RESIDENTIAL 1 & 2 FAMILY PERMIT

01-165214-REV-01-RS

Site Address: 7459 SW 49TH CT
7459 SW 49TH

PROJECT INFORMATION		Occ. Group	Const. Type
Single Family Dwelling	Addition	R3	V-N
Project Description: change to roof framing and trusses			
APPLICANT GUY ALTMAN, ARCHITECT "GUY ALTMAN"		Phone (503) 246-5767	
OWNER ED GAMBEE & KAREN GAMBEE		Phone	
CONTRACTOR DAVID SMITH PLUMBING INC		Phone

Scale: 1/4"
 JOB NAME: RENAISSANCE 1214-02 BR (ORIGIN)

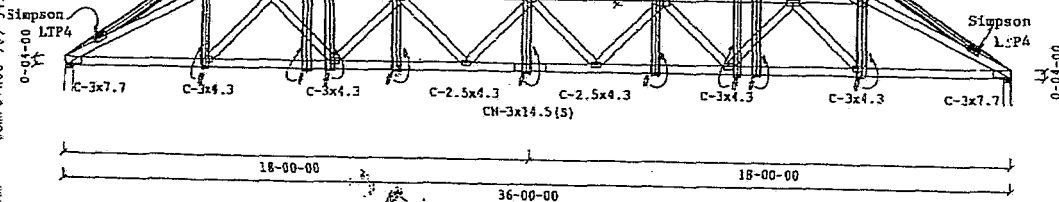
FIELD REPAIR FOR TRUSS TO SLOPE AT A 8:12 PITCH PER 2002
 2x4 DF #1 HORIZONTAL AND SLOPING TOP CHORDS WITH
 SIMPSON LTP4 FRAMING ANCHORS AT HEEL ENDS. INLET 2x4
 BLOCKS UNDER NEW TOP CHORD TO EXISTING OVERFRAMING
 TOP CHORDS WHERE SHOWN * ATTACH 2x4 DF NO. 2
 VERTICAL POSTS TO ONE FACE WITH 160 NAILS PER NAIL NUMBER
 INTERSECTION AND 160 NAILS STAGGERED AT 7" O.C. INTO
 BLOCKS. REFER TO ORIGINAL SEO NO FOR COMPLETE DETAILS
 NOTE: 1X3 BRACING MUST BE INSTALLED AT 24" O.C.
 THROUGHOUT WHERE SHOWN

Scale: 3/16"
FOR RAILWAY: ORALY 4211-02 28 (OREGON)

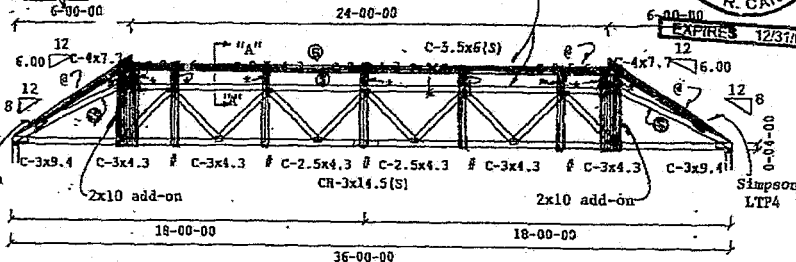
FIELD REPAIR FOR TRUSS TO SLOPE AT A 8:12 PITCH INLET A 2x4 DF #1 HORIZONTAL AND SUPPORT TOP CHORDS WITH SIMPSON L24A FRAMING ANCHORS AT HEEL ENDS. INLET 2x4 BLOCKS UNDER NEW TOP CHORD TO STRUCTURAL PLAT TOP CHORDS WHERE SHOWN *. ATTACH 2x4 DF NO.2 VERTICAL POSTS TO FACE SIDE WITH 3-16d NAILS AT EACH INTERSECTION AND 16d NAILS STAGGERED AT 2' O.C. INTO BLOCKS. ATTACH 2x10 DF #2 VERTICAL ADD-ONS TO FACE SIDE WHERE SHOWN WITH 16d NAILS STAGGERED AT 4' O.C. THROUGHOUT STRUCTURAL VERTICAL MEMBER AND 2' O.C. INTO BLOCK. NOTE: 1x3 BRACING IS REQUIRED AT 24" O.C. THROUGHOUT ENTIRE STRUCTURAL TOP CHORDS. REFER TO ORIGINAL DRAWING FOR COMPLETE DETAILS.

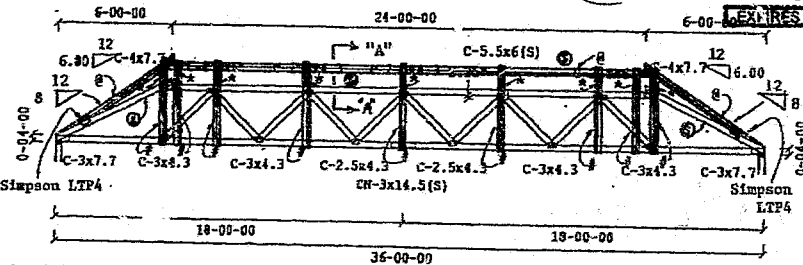
FIELD REPAIR FOR TRUSS IN SLOPE AT DUE TO NUBBLE. 2x4 DF #1 HORIZONTAL AND SLOPING TOP CHORDS WITH SIMPSON LTP4 FRAMING ANCHORS AT HEEL ENDS. 2x4 BLOCKS UNDER NEW TOP CHORD TO EXISTING STRUCTURAL TOP CHORDS WHERE SHOWN. * ATTACH 2x4 DF NO.2 VERTICAL POSTS TO ONE FACE WITH 3-16G NAILS AT EACH INTERSECTION AND 16G NAILS SET FOR 2" OC INTO BLOCKS. REFERTO ADDITIONAL SEG NO FOR COMPLETE DETAILS. NOTE: 1x3 BRACING MUST BE INSTALLED AT 21" OC THROUGHOUT THE TRUSS.

JOB NAME: PERMIT CONSL 4214-02 4214.1 101 5/12

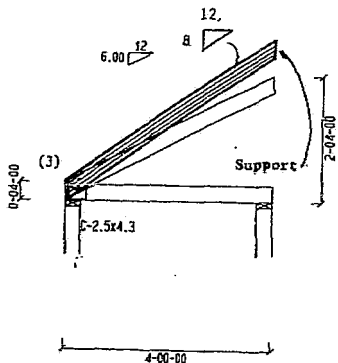
FIELD REPAIR FOR TRUSS TO SLOPE AT A 8:12 PITCH. SCAB A
2X4 DF #2 ADD-ON TO ONE FACE WITH CLUSTERS OF 16d
NAILS IN AMOUNTS SHOWN IN ().

JOB NAME: DENALI CREST #214-02 4249 & 1001 6/12

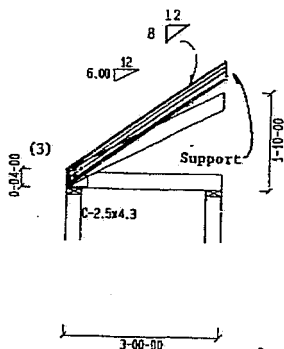
FIELD REPAIR FOR TRUSS TO SLOPE AT A 8:12 PITCH. SCAB A
2x4 DF #2 ADD-ON TO ONE FACE WITH CLUSTERS OF 16G
NAILS IN AMOUNTS SHOWN IN ().
